**AEC DISTRIBUTION FOR PART 50 DOCKET MATERIAL**  
(TEMPORARY FORM)

ENCLOSURES:  
Proposed Change to Tech Specs for Nine Mile Point Unit No. 1

RE: Nine Mile Point Unit No. 1 Docket 50-220

The attached report describes a proposed change for Nine Mile Point Unit No. 1 in accordance with paragraph 50.59 of 10CFR Part 50. It is proposed that an Access Platform be added to the refueling bridge structure to expedite the refueling operation and also enhance safety.

FIGURE 1

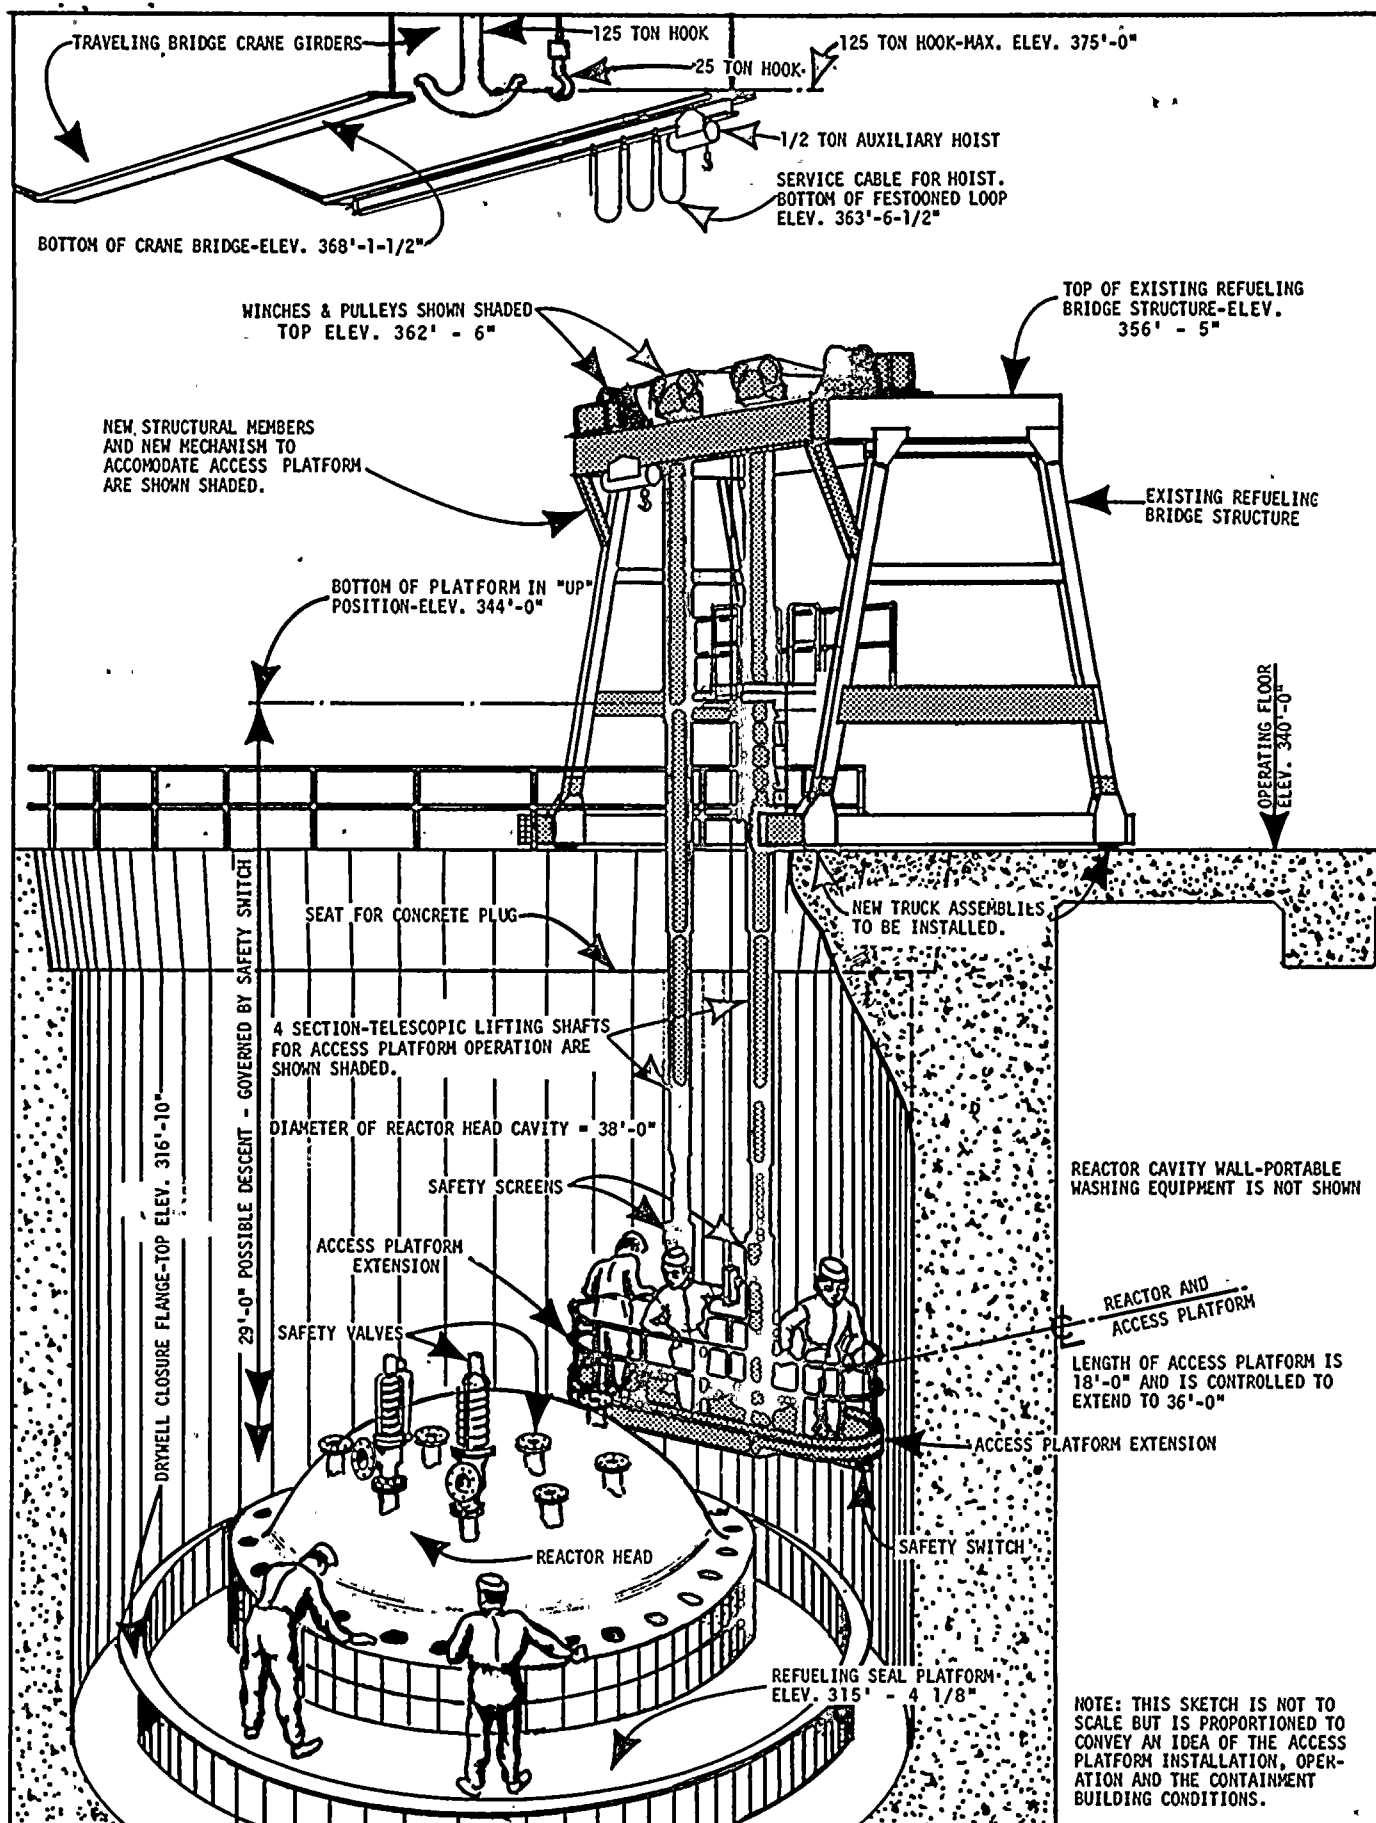
The Access Platform (as shown in Figure 1) for the Station consists of a main platform section with extendible sections at each end; two telescoping tube assemblies which attach the Access Platform to the refueling bridge structure; and two winch hoists, each of which can raise the Access Platform. With the extendible sections fully retracted, the overall length of the Access Platform is 18 feet (excluding any wall cleaning equipment). With the platforms fully extended the overall length of the Access Platform is 36 feet. This length permits access of the walls of the reactor cavity at the greatest width. The design characteristics of the Access Platform are summarized in Table 1. Wall-washing assemblies are mounted on the extendible platforms and can be positioned and locked at any point on the curved section of the extendible platform railing. The high pressure spray nozzles are mounted on a vertical manifold assembly which will maintain the nozzles perpendicular to the wall and at the distance required for efficient cleaning.

Modifications to the refueling bridge structure will be made to obtain smooth bridge operation. These modifications include:

1. Floating the wheels on one platform truck to eliminate wheel binding caused by leg spread.
2. Replacement of the existing walkway with a significantly stiffer structure, so as to afford better distribution of loads due to addition of Access Platform.
3. Replacement of existing bridge drive torque rods with stiffer torque tubes, eliminate wind up associated with current rods.

Some additional modifications to the refueling bridge structure are required to make it suitable for the addition of an Access Platform. These involve the addition of knee braces at each end of the upper structure, the addition of winch hoist mounting structure, the addition of a horizontal brace on each end frame, and the addition of decking above the monorail beam bracing to provide access to the platform components.
